HISTORIC PRESERVATION COMMISSION

TO: Rabbiah Sabbakahn
Department of Permitting Services
FROM: Rebecca Ballo
Historic Preservation Section
Maryland-National Capital Park & Planning Commission Historic Area
SUBJECT: Work Permit #1029631- After the fact demolition of the garage and construction of a new garage

MONTGOMERY COUNTY HISTORIC PRESERVATION COMMISSION
STAFF REPORT

Address:	10221 Montgomery Avenue, Kensington	Meeting Date:	9/6/2023
Resource:	Contributing (Primary One) Resource Kensington Historic District	Report Date:	8/30/2023
Applicant:	Bruce Caswell and Lauren Deichman (Mike Roberson/McFarland Woods, Agent)	Public Notice:	8/23/2023
Review:	HAWP	Tax Credit:	N/A
Case Number:	1029631	Staff:	Rebecca Ballo
PROPOSAL:	After the fact demolition of the garage and construction of a new garage

2 PROPOSED RIGHT SIDE GARAGE ELEVATION
Scale: 1/4"=1'-0"

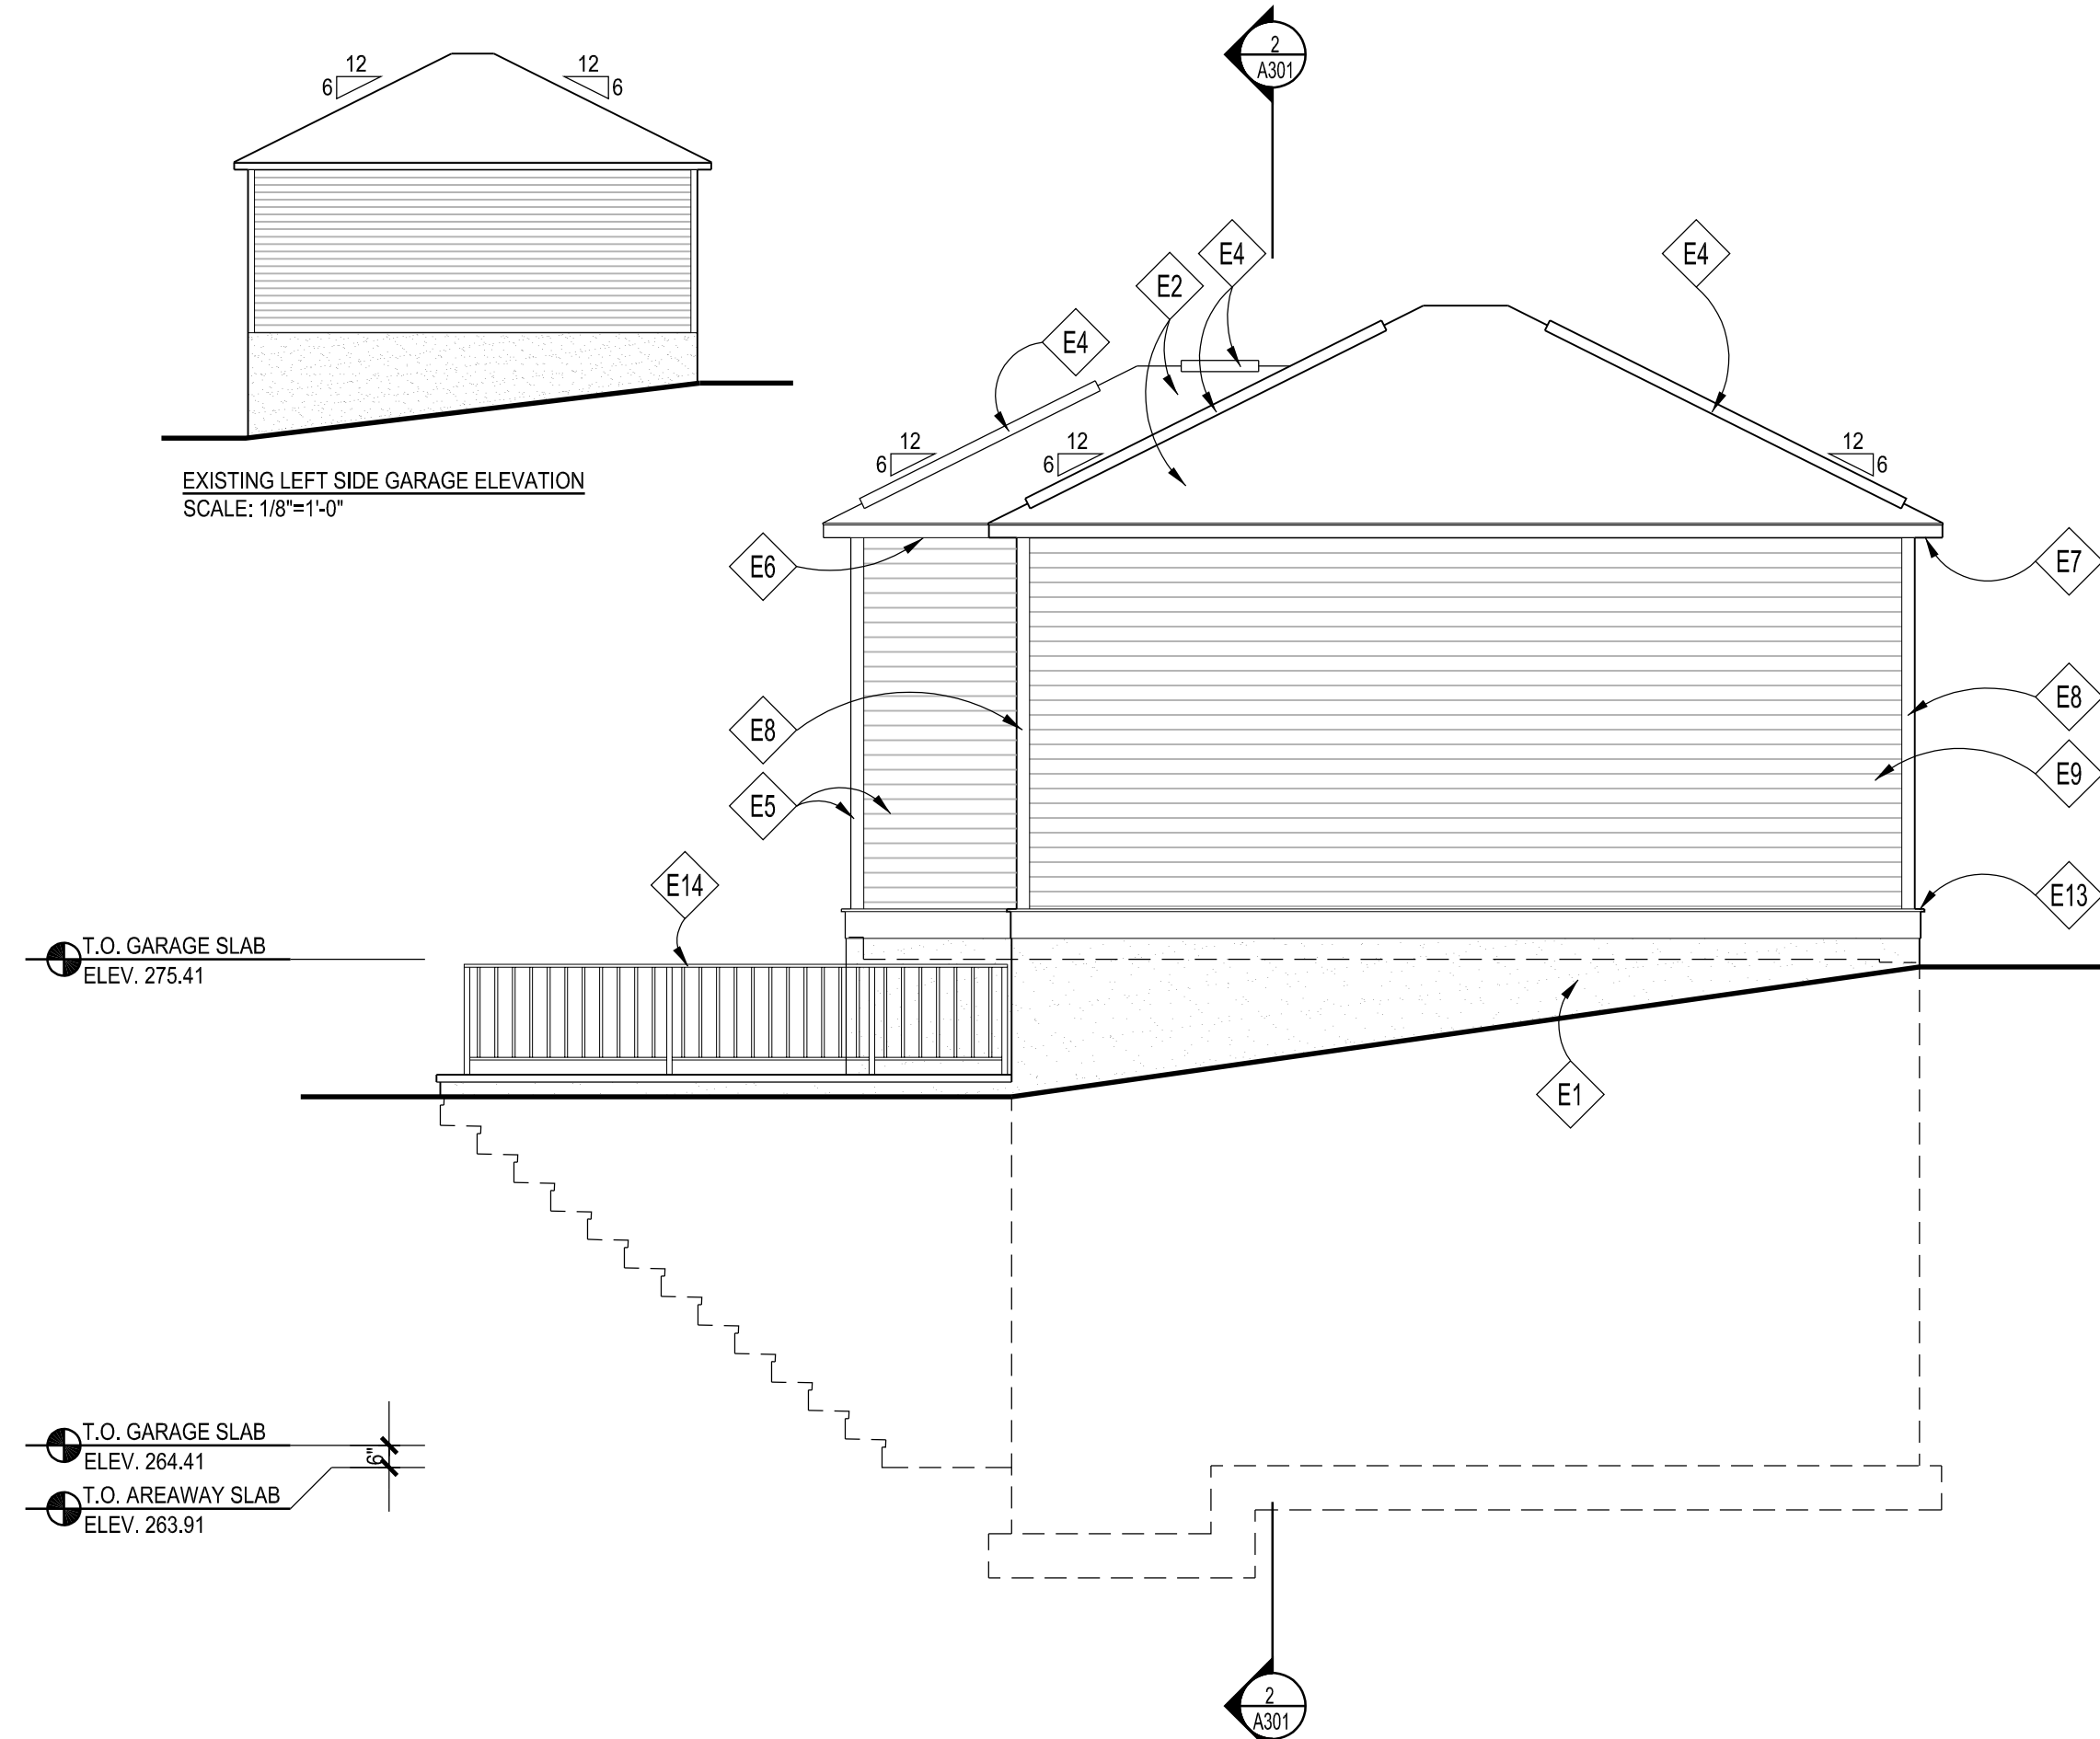
- 1) The applicant shall submit a corrected copy of the as-built drawings showing the new structure from all four elevations, in plan, and with accurate material notations, noting that this is “New Construction”;

- 2) The single hung windows shall be 6/1 to match those from the demolished garage. The windows may be wood or aluminum clad wood, with simulated-divided-lite spacers. Final details of the windows shall be shown on the revised drawings;

1 ELEVATION
 Scale: 1/4"=1'-0"

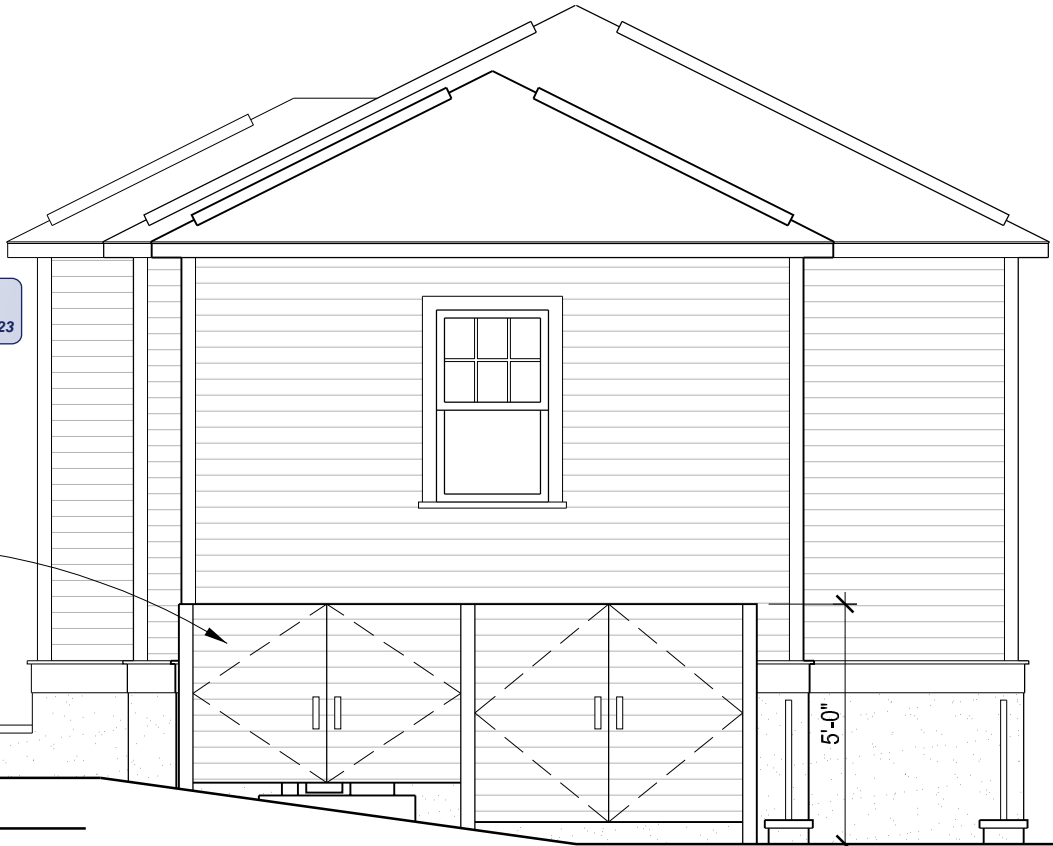
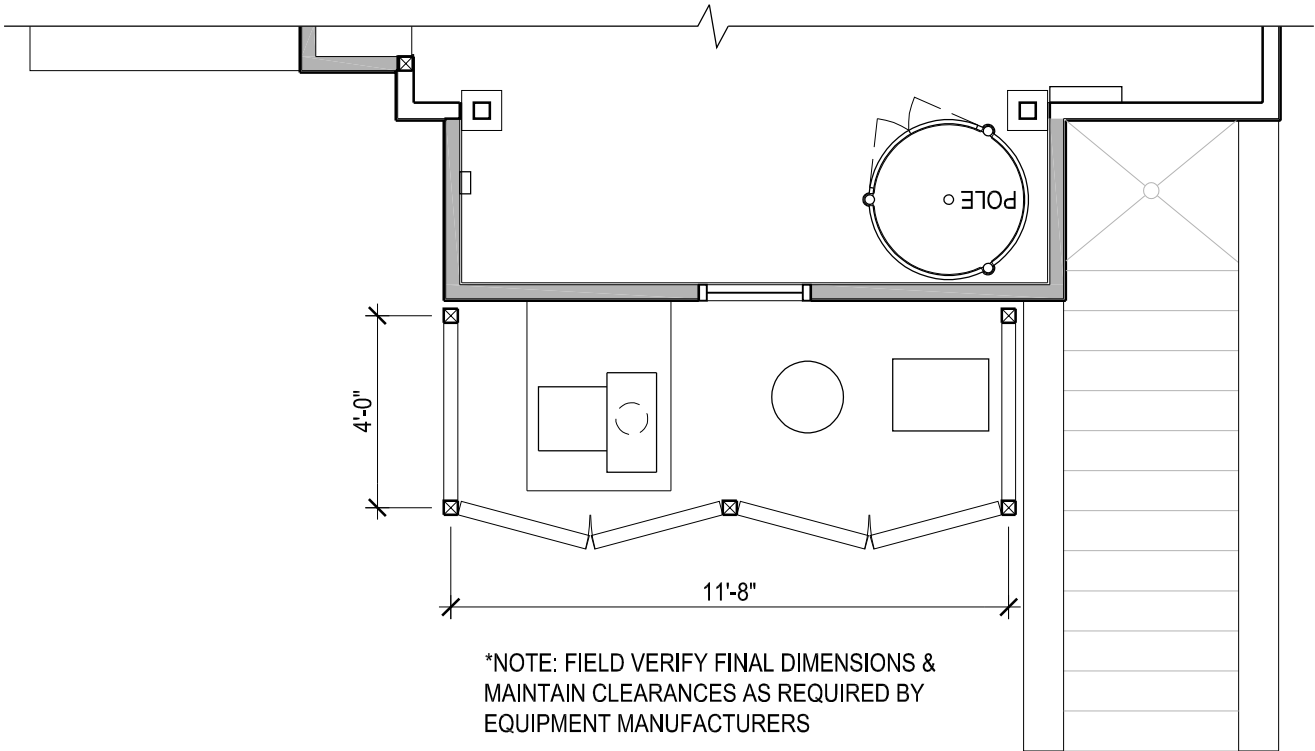
- 5) ~~4)~~ The pool equipment shall be screened with either four-season evergreen plantings or with wood, horizontal panels, or another small structure. Final details of the screening shall be shown on the revised drawings; and,
